Location of Construction: 559 A Congress Street 04101		Owner: *** Rita Yarnold		Phone: 775-3838		Permit No: <b>990950</b>	
Owner Address: ** 559 Congress St. Portland, ME 04101		Lessee/Buyer's Name:		Phone:		BusinessName:	
Contractor Name: Len Hoseit		Address: 58 Westmore Biddeford Maine 04005		Phone: 207-284-1223		Permit Issued:  SEP - 7	
Past Use:  Hair Salon		Proposed Use:  Same		COST OF WORK: \$ 600.00		PERMIT FEE: \$ 30.00	
				FIRE DEPT. <input checked="" type="checkbox"/> Approved <input type="checkbox"/> Denied		INSPECTION: Use Group: Type:	
				Signature: <i>[Signature]</i>		Signature:	
Proposed Project Description: Moving an entry door, and building a wall to create additional office space.				PEDESTRIAN ACTIVITIES DISTRICT (P.A.D.) Action: Approved <input type="checkbox"/> Approved with Conditions: <input type="checkbox"/> Denied <input type="checkbox"/>			
Permit Taken By: UB		Date Applied For: 9-2-99

BUILDING PERMIT REPORT

REASON FOR PERMIT: Interior office renovations

Second Floor  
of 559  
Congress  
Street

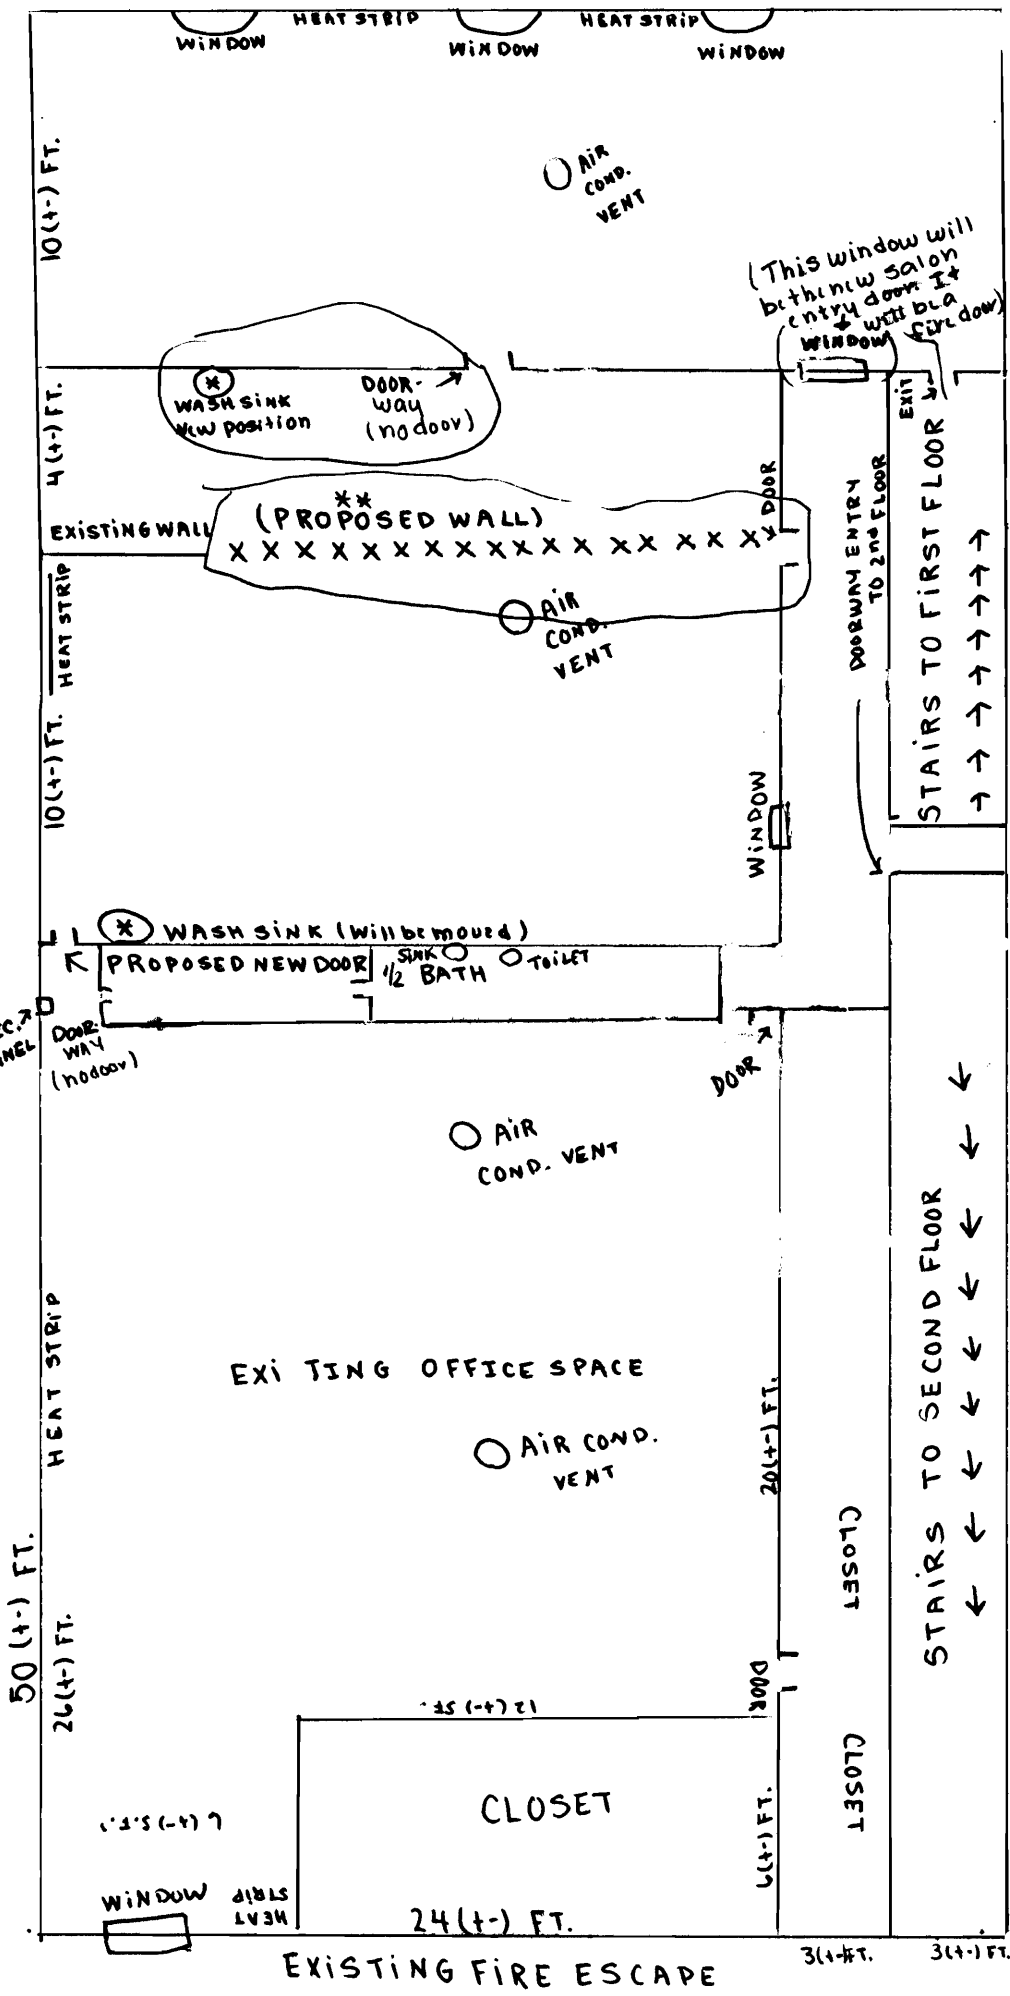
12-6-99 Inspected by SAM H. Only remaining issue is GIRE door fit

- X 35. New door in EXIT way shall be have a one (1) hour fire rating.
36. \_\_\_\_\_
37. \_\_\_\_\_
38. \_\_\_\_\_

**\*\*On the basis of plans submitted and conditions placed on these plans any deviations shall require a separate approval.**
